SALT RIVER CHANNELIZATION DRAFT DESIGN CONCEPT REPORT

Interoffice Memorandum

CMT. NO.	SUBJECT: SALT RIVER CHANNEL PLANS	<input type="checkbox"/> FILE _____ <input type="checkbox"/> DESTROY _____
<p>TO: Dick Perreault FROM: L.C. Huang DATE: 1-23-89 Via: Nick Karan <i>MPK</i></p>		
<p>WE HAVE REVIEWED THE 90% PLANS FOR THE SALT RIVER CHANNELIZATION DESIGN; AND HAVE THE FOLLOWING COMMENTS:</p>		
<p><u>CHANNEL PLANS</u></p>		
<p>CH-1.4 to 1.6 HOW ARE GABIONS TO BE ANCHORED?</p>		
<p>CH-1.5 SHOULD THE DRAIN PIPE DETAIL BE ON DWG NO. CH-10.2</p>		
<p>CH-2.6. 100 STATION FOR THE 8'x4' BOX READ AS 149+42.11, HOWEVER IT WAS SHOWN AS 149+42.16 IN DWG. NO. CH-9.2.</p>		
<p>CH-2.8 SOUTH LEVEE TOE ELEVATION AT STA. 195+00 READ AS 1106.8, BUT IT WAS SHOWN AS 1106.9 IN DWG. NO. CH-2.10</p>		
<p>CH-2.13. STATIONS OF THE SOUTH GUIDE BANK OPENINGS SHOULD BE GIVEN. WHAT IS THE FLOW DISCHARGE THROUGH THE OPENINGS, THE SOIL-CEMENT SHOULD WRAP AROUND THE BACKSIDE (SOUTH) OF</p>

DRAFT
CONCEPT DESIGN REPORT

FIGURE 8
TYPICAL CROSS SECTION
PAPAGO CHANNELIZATION

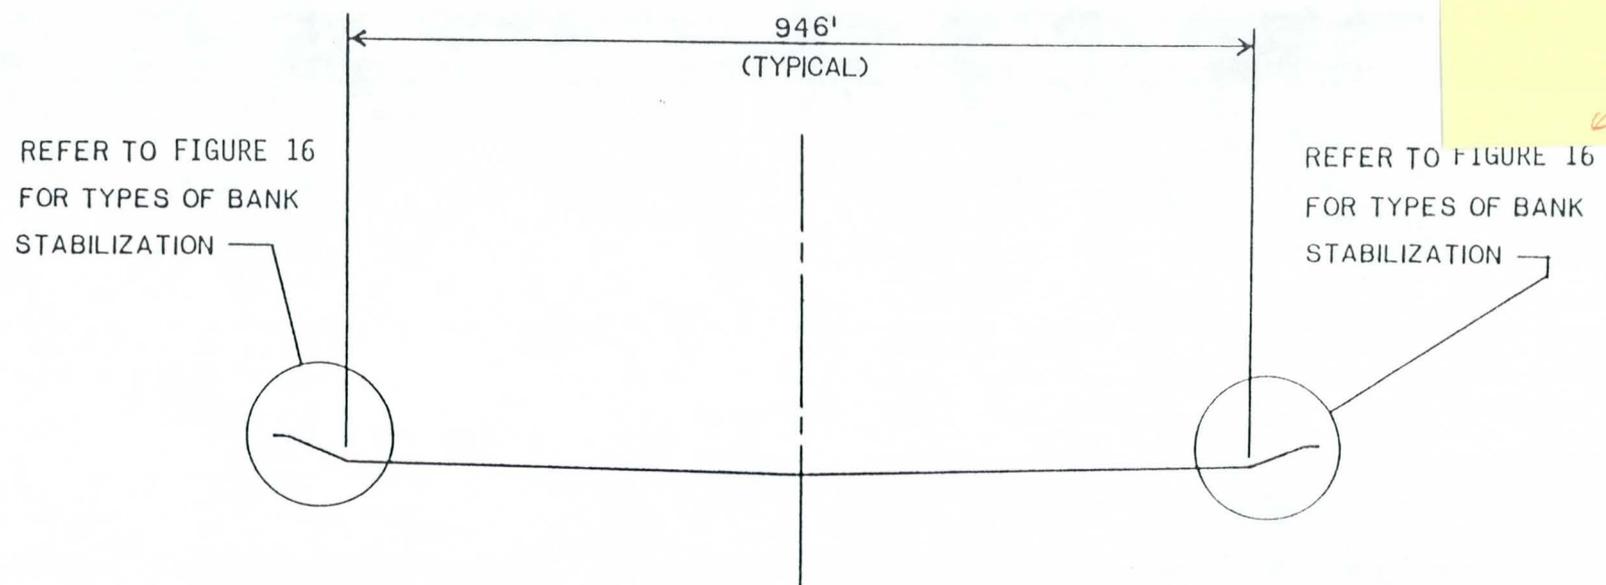
Figure 19?

BANK STABILIZATION TYPE 'A'
(TYPICAL)

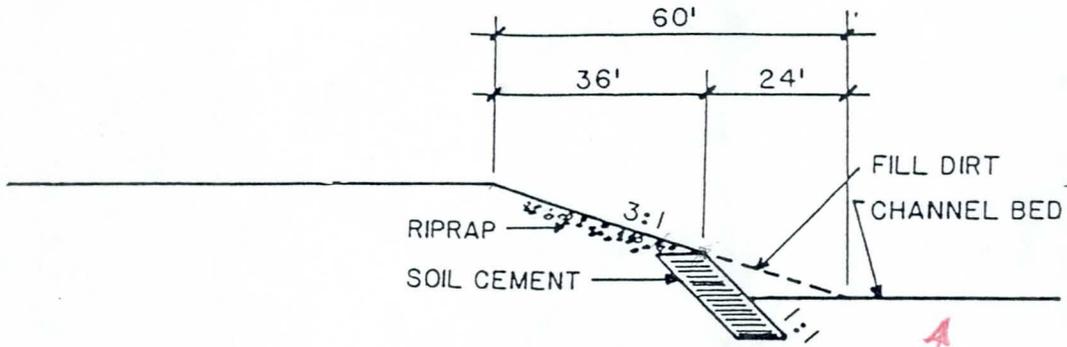
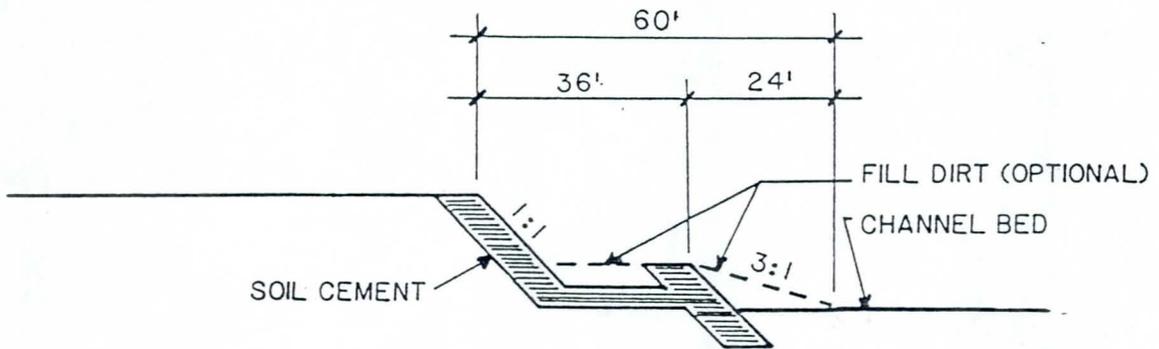
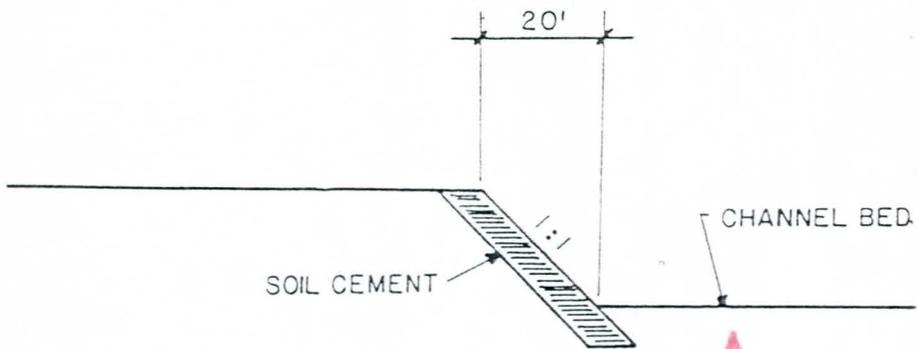
how was this established?
Cont. on p. 86

GRID CONFINEMENT SYSTEM

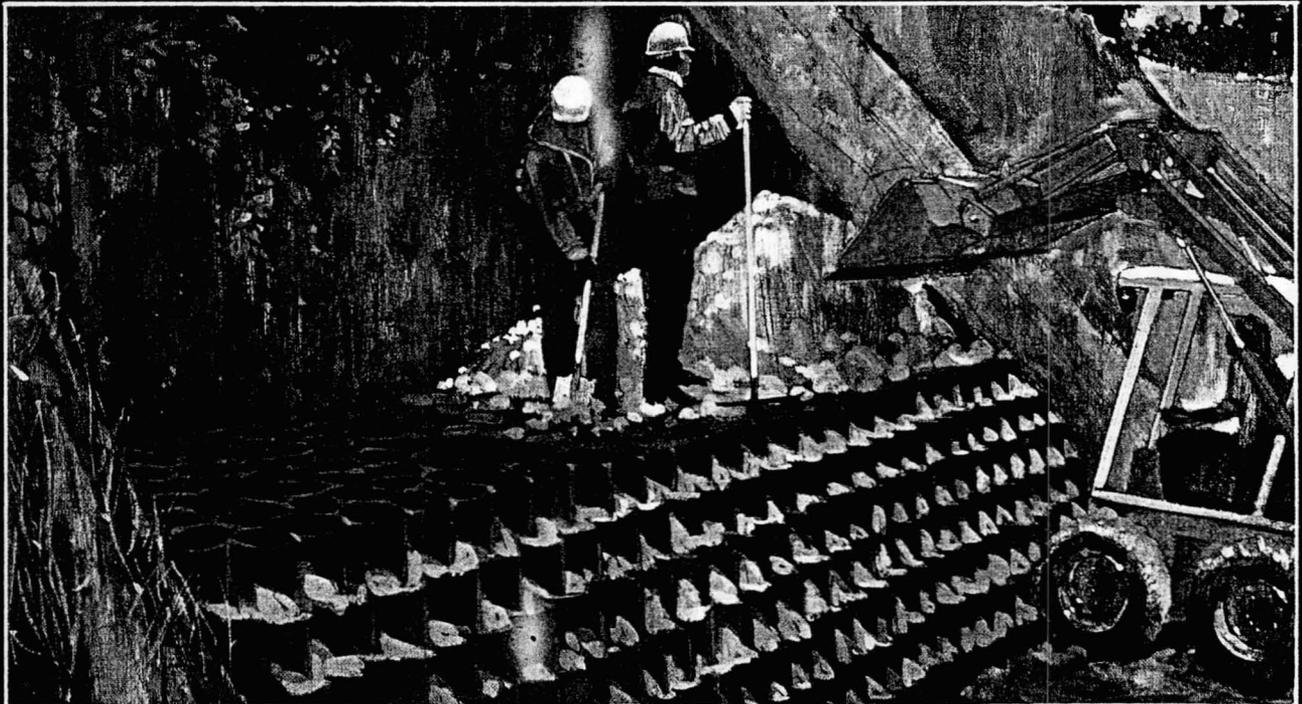
Why 5.4'
not "factor"
